Subject: Notice of Violation No. R9-2010-0014
The Heights Development – Poway, California
WDID No. 9 37C345205

**NOTICE OF VIOLATION
NO. R9-2010-0014**

**Subject Site: The Heights Development in the City of Poway
WDID NO. 9 37C345205**

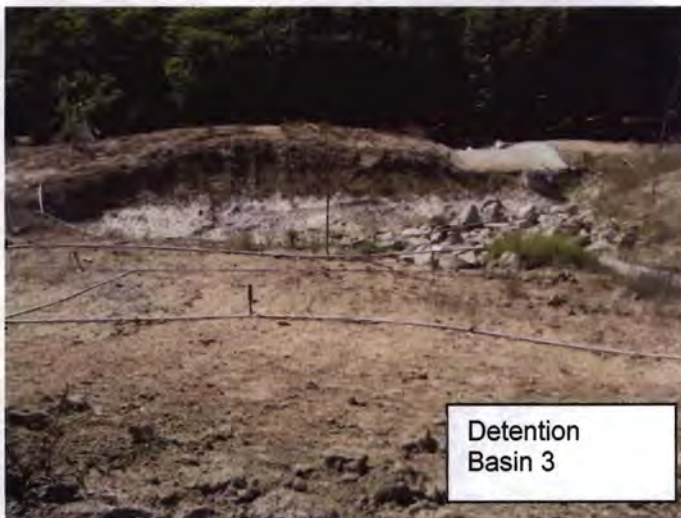
Sediment was present on the spillway located in the detention basin nearest the home at the top of the hill. The presence of sediment is evidence of a historical release of sediment from the detention basin. This may be further evidence that the basin is too small for the amount of flow directed towards the basin. The developer was asked to clean the spillway and clear the area around the standpipe and to clear the standpipe orifices such that the basin can operate as designed for detention and retention. See confirmation email from Geoff Sherman 10/2/09 9:35 am.

Material in drainage swales. The developer was notified that the swales should be cleaned out and remain clear of debris so as not to discharge debris and sediment during a storm event. See confirmation email from Geoff Sherman 10/2/09 9:35 am.
